## 《 민주연구원 현안긴급토론회 》 IAEA 후쿠시마 오염수 보고서 검증

# Review of the IAEA Comprehensive ALPS Report

REPORT ON THE
SAFETY REVIEW
OF THE ALPS-TREATED
WATER AT THE
FUKUSHIMA DAIICHI
NUCLEAR POWER STATION

### 3. Existing Radiation Risks (page 31)

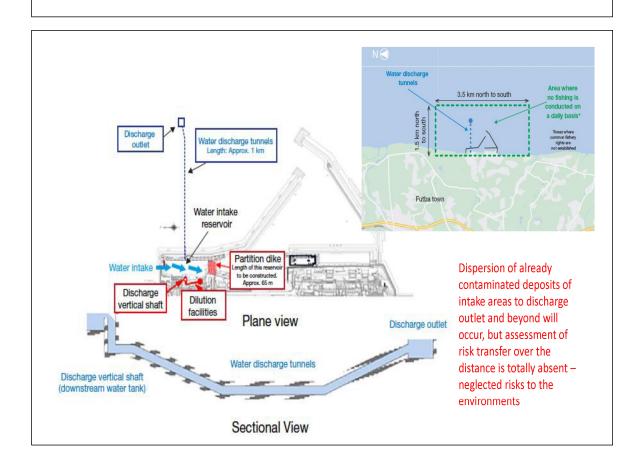
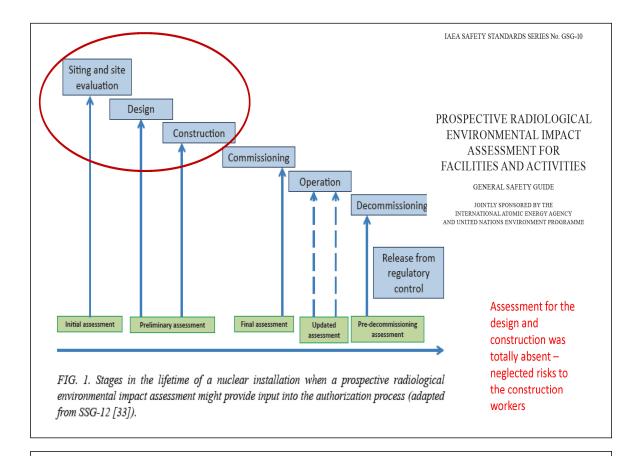
- Protective actions to reduce existing or unregulated radiation risks must be justified and optimized.
- The IAEA safety fundamentals principles publication provides examples of situations where the fundamental safety principle for existing exposure situations would be applicable. These include:
- (i) those situations concerning radiation exposure of essentially natural origin, for example, exposure due to radon in dwellings,
- (ii) those situations concerning extant exposure situations that arises from human activities conducted in the past that were never subject to regulatory control, or that were subject to a non-rigorous regime of control; and,
- (iii) those following remediation measures taken following an uncontrolled release of radionuclides to the environment.
- The discharge of the ALPS treated water does not fall into any of these situations.

### Only as a planned exposure (?)

- The FDNPS is managed as an existing exposure situation in the Japanese regulatory framework; however the discharges of ALPS treated water into the sea, which are controlled discharges, are viewed as a planned exposure situation by NRA. (page 31)
- However, the planned exposure will involve the aggravation of the existing risks to the environment and also to workers, especially in the heavily contaminated areas of power plant.

Figure 3.11. Overview of methodology used by TEPCO to select radionuclides to be measures and assessed prior to discharge

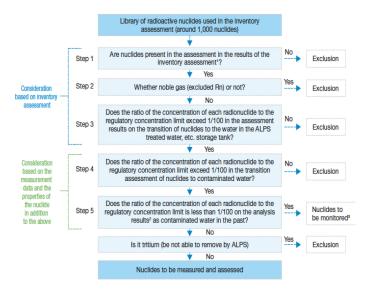
### Credibility of Source Profiles

- Performance of ALPS not verified.
- The differences between normal operation and accidents, in terms of the released fission products profiles, have not been examined thoroughly.
